Wisconsin Department of Transportation

Proposal #02: 1016-05-70
Tomah – Mauston
STH 82 Interchng/B29-36,152-155,157
IH 90
Juneau County

This is Addendum No. 02, which provides for the following:

ADDENDUM NO. 02

Addendum No. 02
ID 1016-05-70
Revised Sheet 27
February 4, 2022

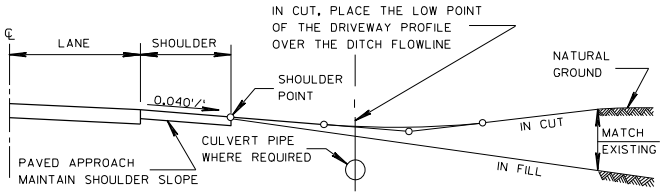
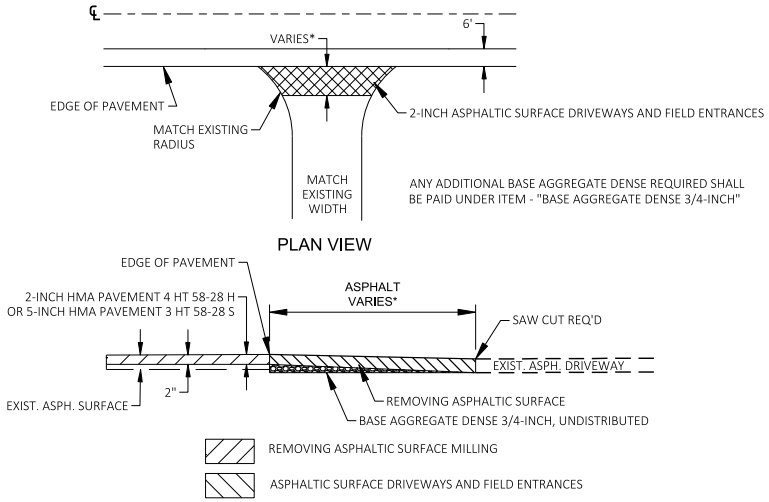
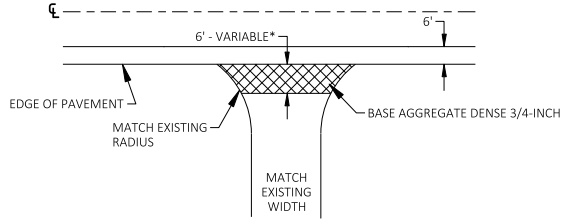
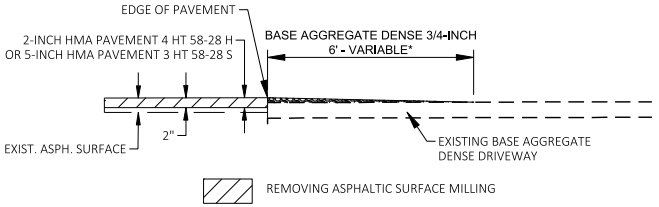
Revised Plan Sheets	
Plan Sheet	Plan Sheet Title (brief description of changes to sheet)
27	Construction Detail (Removed cross drain installation detail)
31	Construction Detail (Added detail to show areas of borrow & select borrow)
52-53	Paving Details (Moved ramp gates)
55-56	Paving Details (Moved ramp gates)
145	Permanent Signing (Moved ramp gates)
151-152	Permanent Signing (Moved ramp gates)
445-447	Miscellaneous Quantities (Revised earthwork table for borrow)
501-502	Miscellaneous Quantities (Revised ramp gates and bases)
513	Plan and profile (Added storm sewer pipe that was not shown)
520-521	Plan and profile (Added note to not work in parcels 1 and 2)
528-529	Plan and profile (Added note to not work in parcels 2 and 3)
532-533	Plan and profile (Moved ramp gate locations)
543	Plan and profile (Moved ramp gate locations)
548-549	Plan and profile (Moved ramp gate locations)
575-576	Plan and profile (Moved ramp gate locations)

Addendum No. 02
ID 1016-05-70
Revised Sheet 578
February 4, 2022

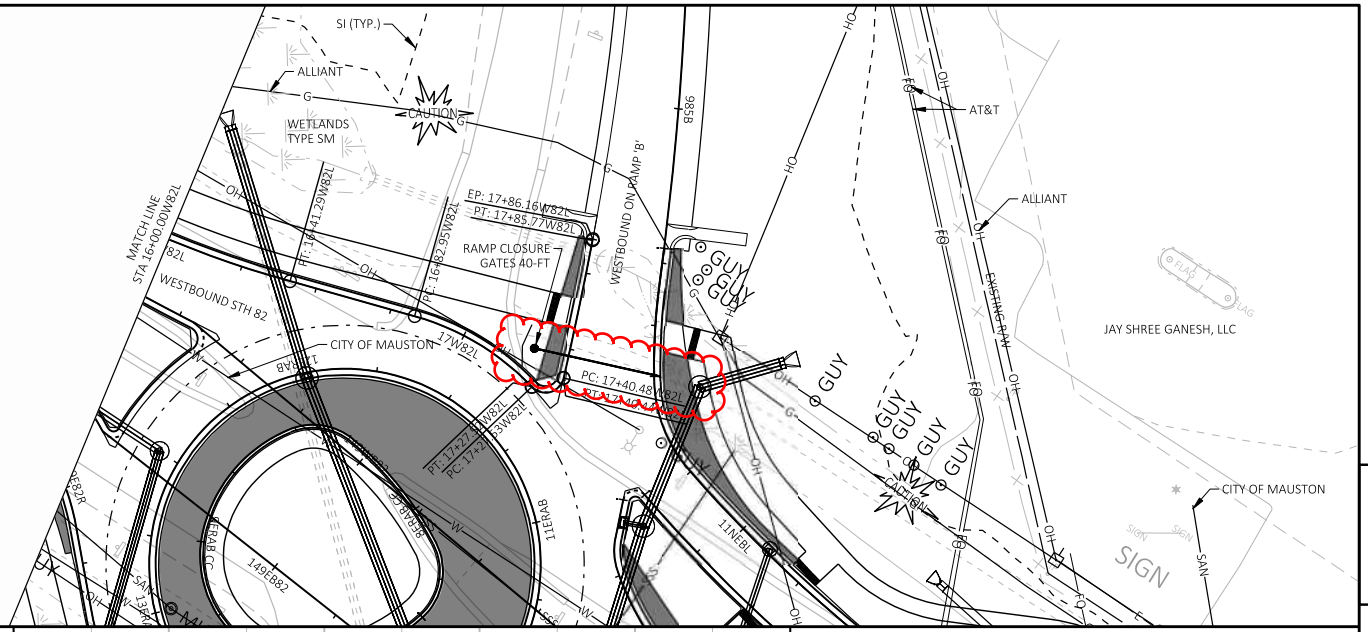
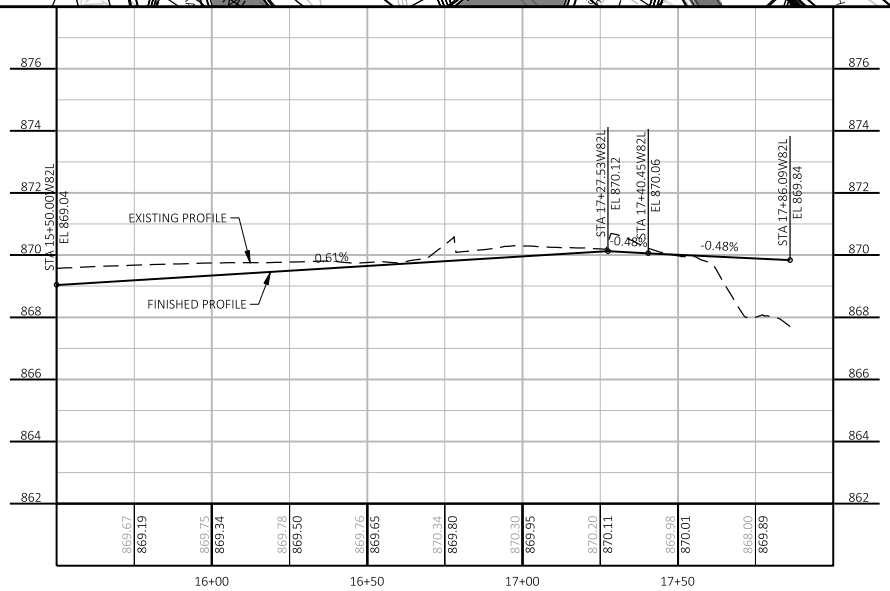
578	Plan and profile (Moved ramp gate locations)
581	Plan and profile (Moved ramp gate locations)
583	Plan and profile (Moved ramp gate locations)
998-1018	Earthwork (Revised earthwork charts for borrow & select borrow)
